Fuel Cells of the V-22 *Osprey* Joint  
Advanced Vertical Aircraft  
(D-2003-013)

Department of Defense  
Office of the Inspector General

SUBJECT: Report on the Fuel Cells of the V-22 *Osprey* Joint Advanced Vertical  
Aircraft (Report No. D-2003-013)

Naval Safety Center Data

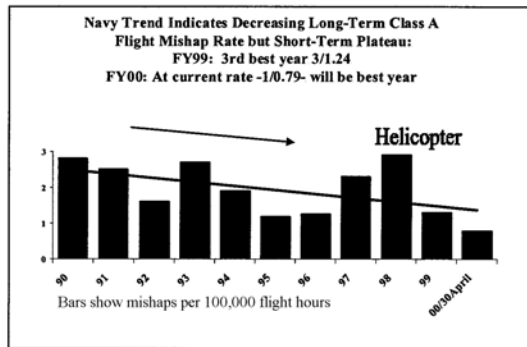
5. What was the source of the helicopter data used for the safety assessment, what was the population and population size the data was developed from, and what timeframe does the data represent? Did the data include helicopters without the capability to make an autorotation landing in the event of engine failure? Please provide a copy of the data used. (NOTE: We

**5. What was the source of the helicopter data used for the safety assessment, what was the population and population size the data was developed from, and what timeframe does the data represent? Did the data include helicopters without the capability to make an autorotation landing in the event of engine failure? Please provide a copy of the data used.**

\* Autorotations are performed in response to either total power loss (requires dual engine failures in all Navy/Marine Corp helicopters, including V-22) or due to tail rotor failures (for conventional helicopters). The vast majority of autorotations are due to tail rotor failures. Lack of tail-rotor will reduce the need for V-22 autorotation capability (compared to single rotor helicopters). The probability of having to conduct an autorotation is considered improbable. The data source for mishap rate is provided below:

**Navy Response.** The V-22 Program Office stated that autorotations are performed in response to total power loss, resulting from dual engine failures in Navy and Marine Corp helicopters, including the V-22; or in response to tail-rotor failures in conventional helicopters for which the vast majority of autorotations occur. Because the V-22 does not have a tail rotor, the need for autorotation capability is reduced. For its mishap rate, the V-22 Program Office provided a graph, “Naval Safety Center Data,” as the data source. In addition, the Program Office listed four data sources to support the “Naval Safety Center Data” assessment.

**Audit Response.** The Navy did not provide the population and population size for the “Naval Safety Center Data” and copies of support data. Further, the times given in the data sources were unclear about whether they were timeframes of data or publication dates of studies.

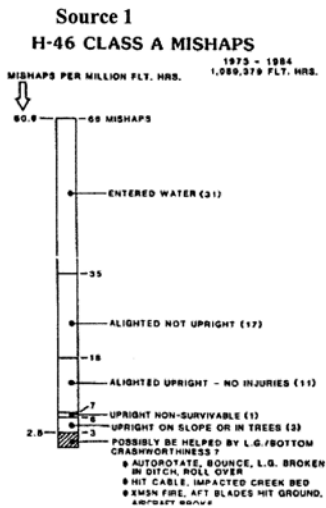
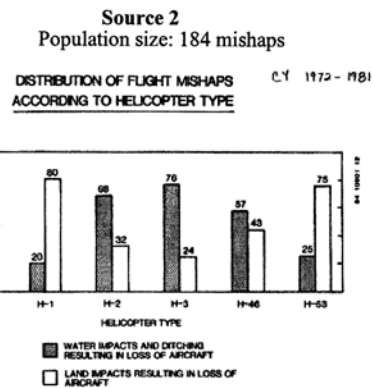
7. What was the source for the data that was used to develop the "probability that a crash occurs over land" factor, what was the population and population size the data was developed from, and what timeframe does the data represent? Please provide a copy of the data used.

**7. What was the source for the data that was used to develop the “probability that a crash occurs over land” factor, what was the population and population size the data was developed from, and what timeframe does the data represent? Please provide a copy of the data used.**

The V-22 is a replacement for the H-46. The data below fully supports the 50% over land statement.

H-46 Data: Source 1 data source shows 31/66 = 47% water crashes, Source 2 data 57% water crashes, Source 4 data shows 32/52 or 62% water crashes.

Source 3 data indicates that for all Navy/Marine Corps Helicopters, 157/284 or 55% of all crashes occurred into the water

**Navy Response.** The V-22 Program Office stated that the V-22 is a replacement for the H-46 helicopter and provided 4 sources for data to support the “probability that a crash occurs over land” factor of 50 percent. The 4 sources showed the probabilities of water crashes as 47 percent, 57 percent, 55 percent, and 62 percent, respectively.

**Audit Response.** The source 1 and 2 data were old, 1973 through 1984 and 1972 through 1981, respectively; and the source 3 data were unclear as to whether 55 percent of the helicopter mishaps occurred over water. Further, the source 4 data were not for EMD aircraft and generally supported the “probability of crash over land” factor equating to 50 percent.

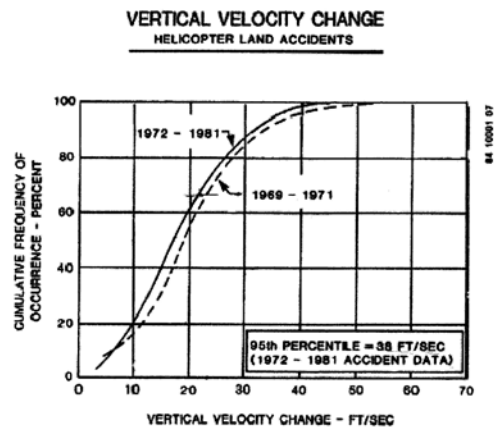
8. Please provide evidence that the factors "probability that a crash is survivable" and "probability that a crash occurs over land" are actually mathematically independent factors.

**8. Please provide evidence that the factors “probability that a crash is survivable” and “probability that a crash occurs over land” are actually mathematically independent factors.**

Source 4 data indicates that:

32 of the 157 water mishaps (or 20% of water mishaps were considered non-survivable).  
44 out of 127 land mishaps (or 35% of land mishaps were considered non-survivable).

**Navy Response.** The V-22 Program office stated that data is not currently available to show that the “probability that a crash is survivable” and the “probability that a crash occurs over land” are totally independent. Further, the Program Office stated that some degree of statistical dependence may exist; however, that degree is unknown. In the V-22 mishaps, three were land crashes and one was survivable. The V-22 Program Office also stated that fuel cell crashworthiness would not have been a factor in 75 percent (3 out of 4) of the mishaps because impact loads far exceeded the survivable mishap threshold for humans. Further, the Program Office stated that source data indicates that 20 percent (32 divided by 157) of water mishaps and 35 percent (44 divided by 127) of land mishaps were considered nonsurvivable.
